PIPER VILLAGE WEST

Early Design Guidance #2
Analytic Design Proposal Packet

Submittal Date
Sep. 23, 2009

Grid

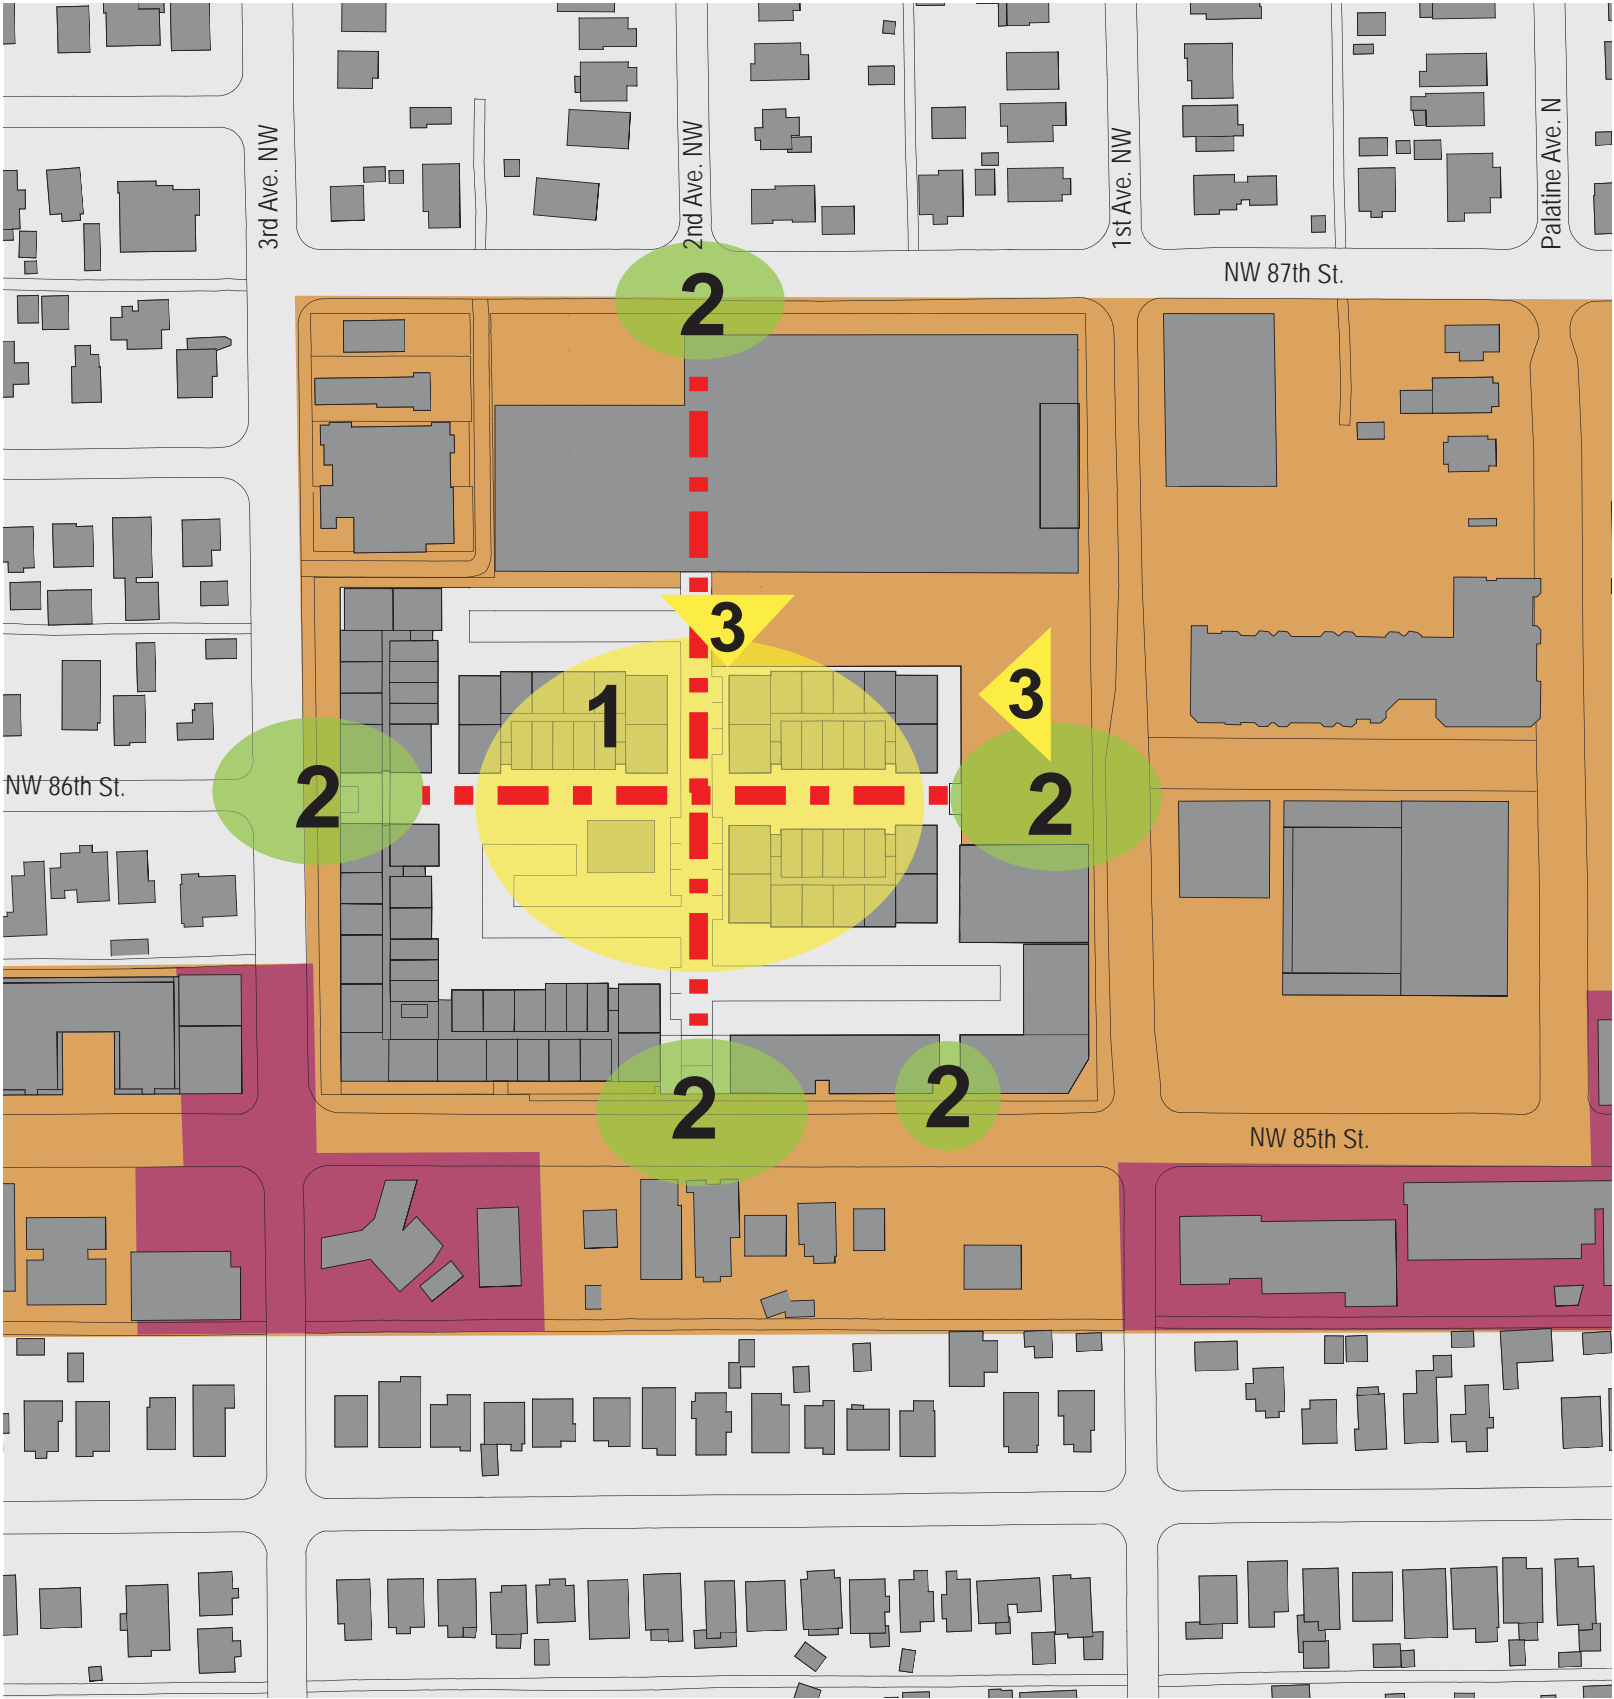
The development site is very large. It is large enough to be four “normal” sized blocks and sits within a pattern of streets such that 2nd Ave. N.W. and N.W. 86th St. would bisect it if they continued uninterrupted across it. Recognition of the surrounding street grid should be incorporated into the site plan. Measures for pedestrian travel through the site block along these routes should be incorporated. Also the architecture of the site should include connections to these two streets and there should be landscaped, inviting and interesting Public, pedestrian routes across the site, north/south and east/west, in a manner which connects two the street grids in a reasonable manner.

The Board observed that it is desirable to have as many ways in and out of the site as possible. They endorsed the multiple driveway approach and also called for multiple pedestrian entry points in locations that make sense in relation to surrounding streets, sites, sidewalks and traffic control measures.

A Board member indicated he would be interested to see how the Fred Meyer would function with two points of access; thereby increasing connectivity between the store and the interior of the site.

1 The establishment of the city street grid relative to the site is the driving organizational planning tool for the preferred alternative A. The quality and character of the connection points it creates are elaborated on in the Site Connections and Open Space section.

2 Preferred alternative A features a hierarchy of site connection points. These are identified here and on “Open Space Circulation Hierarchy” (page 04).

3 The separation between store entries is approximately 200’.

Height / Bulk / Scale

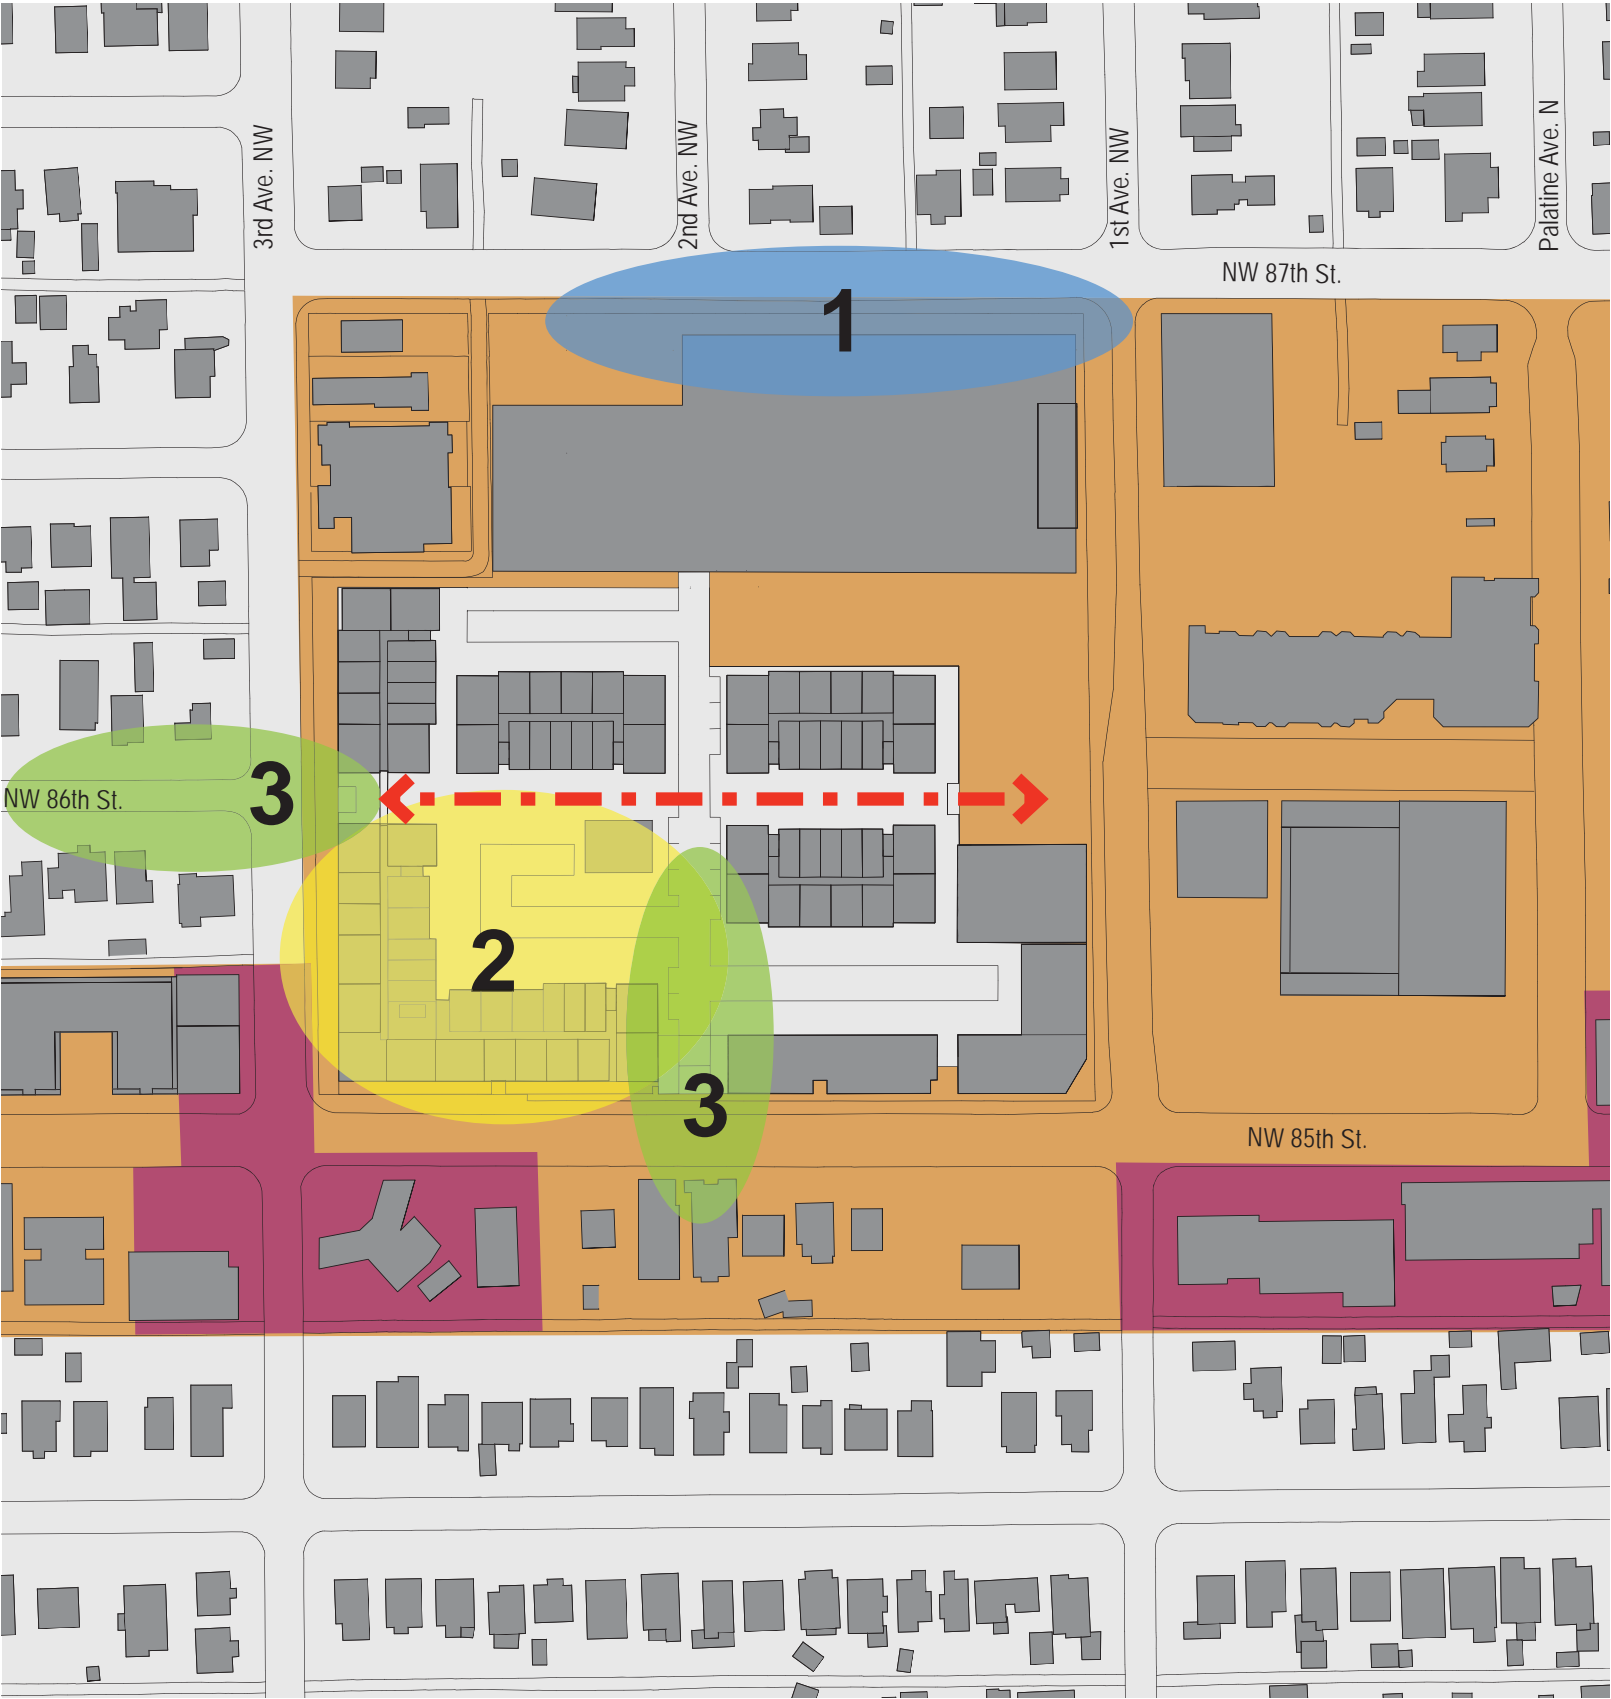
The Board stated that additional height for residential structures would best be located away from N.W. 87th St. and the single family areas to the north. It expressed considerable concern about the size of the proposal site and the long structure facades along street frontages that are likely to result. Architectural measures should be employed to create a scale compatible with surrounding uses. The massing of the structure(s) on the site as a whole needs to be carefully designed to be contextually sensitive.

- 1
- The housing that was previously on NW 87th Street has been reallocated to other portions of the site. This also provides the opportunity to maintain the existing coniferous trees that are on the north side of the existing Fred Meyer store.
- 2
- The focus of the housing component of the project is now concentrated along 3rd Ave NW and 85th. The proposal envisions an urban street wall along these street frontages as a result.
- 3
- Contextual sensitivity: to respond to the neighborhood and surrounding street grid, the massing of the project will respond to major street axis by creating through connections.

Urban Core

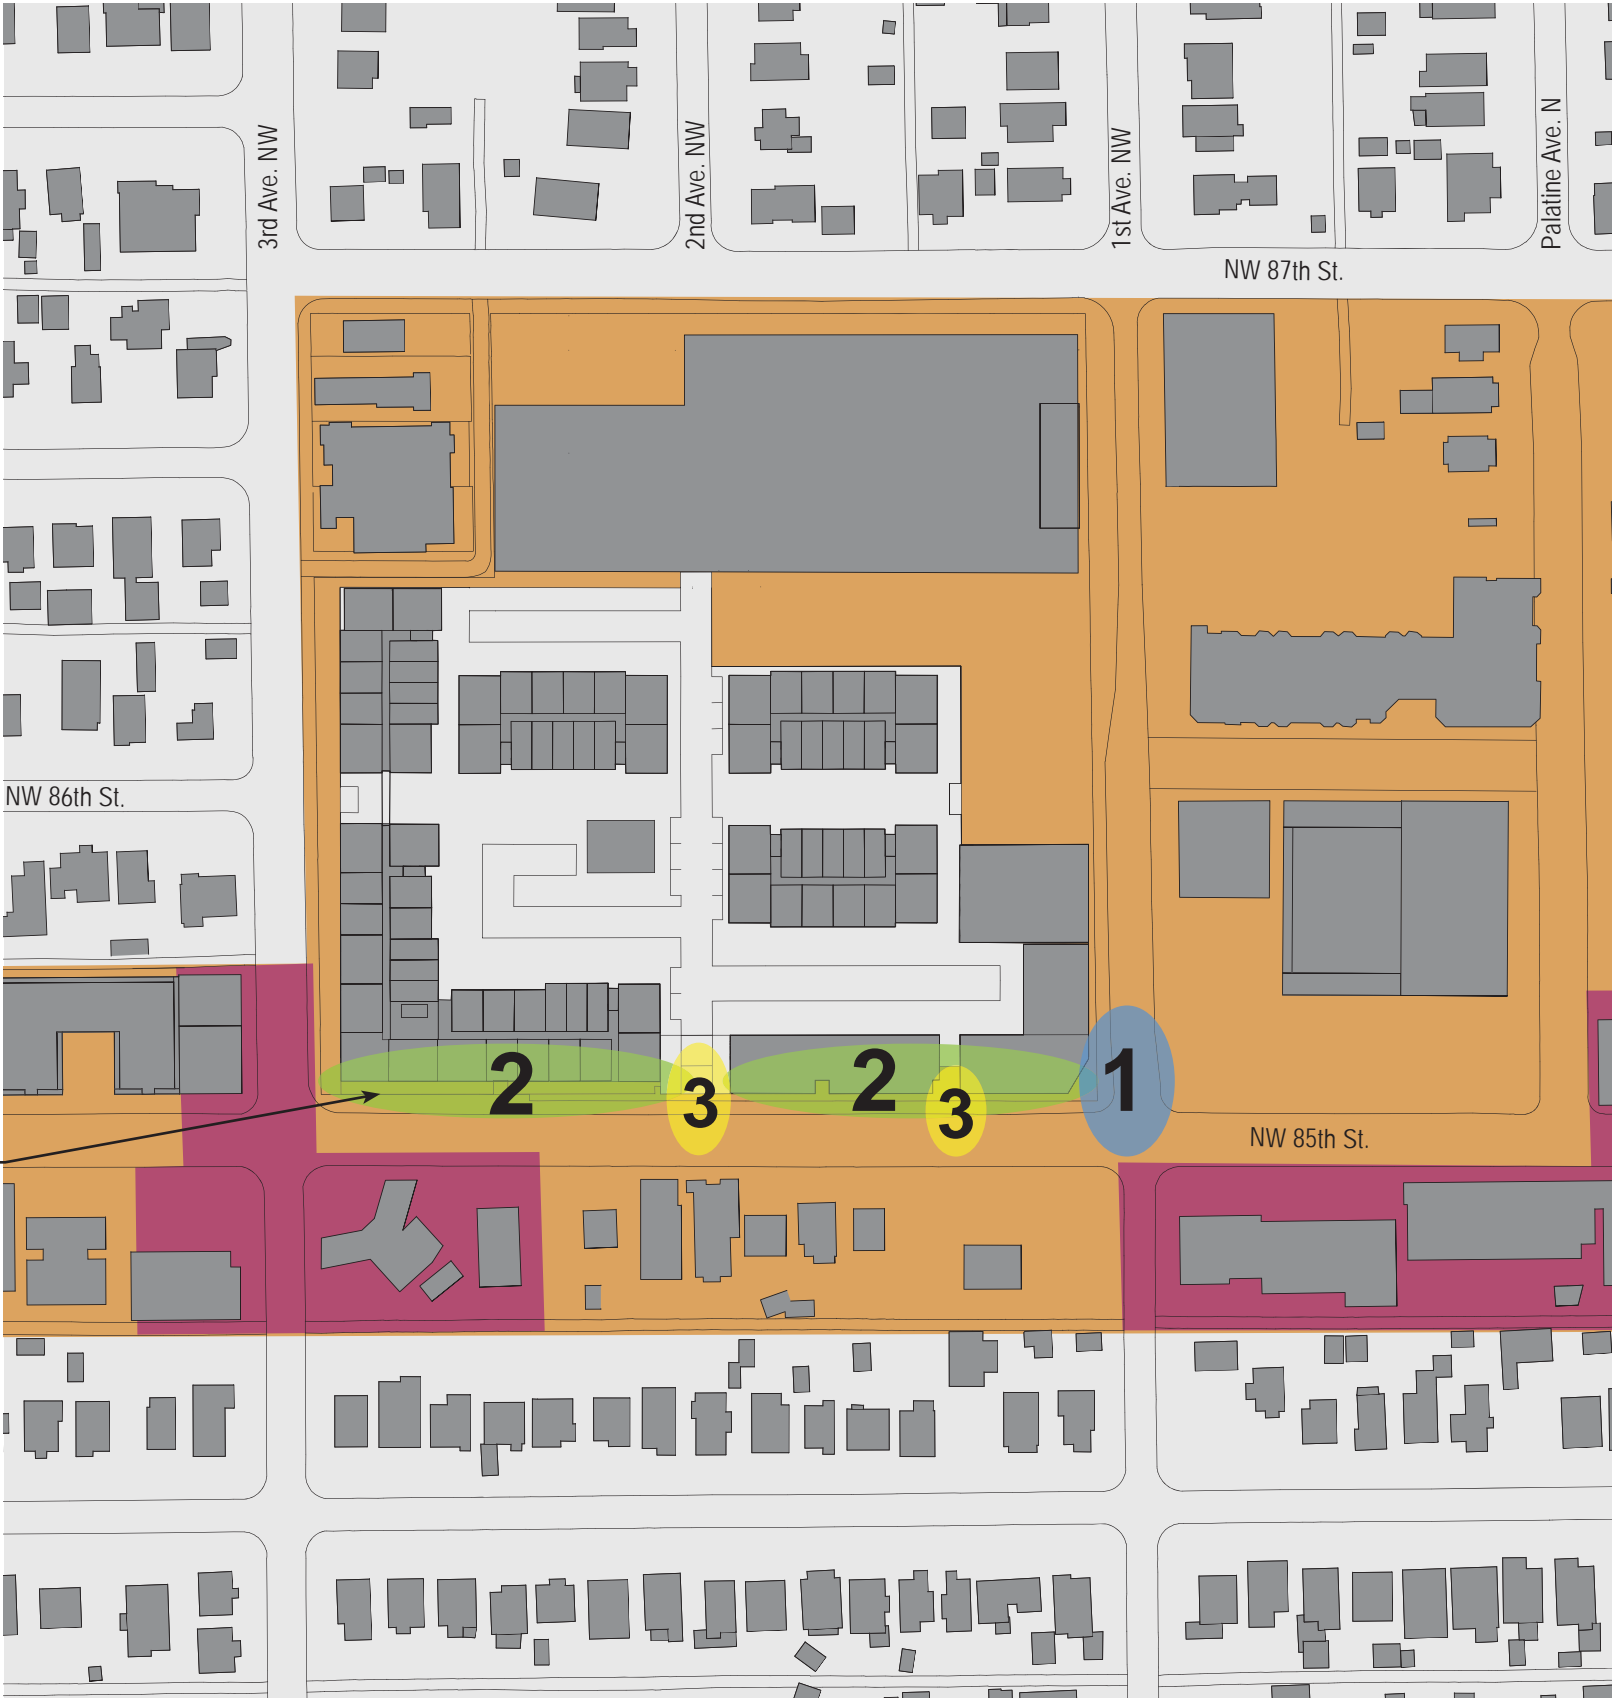
Board members asked that refinement of the publicly accessible spaces be made. The site should be designed with pedestrian permeability across it in an approximation of a grid dividing four quadrants.

We see Piper Commons as the urban core of our project, as it is at the crossroads of Morrow and 1st Ave NW, and also our through-site NW 86th connection. This space will serve as Fred Meyer's main entry, and can be used for a variety of programmable uses. We have elaborated on the hierarchy of open space further in this proposal.
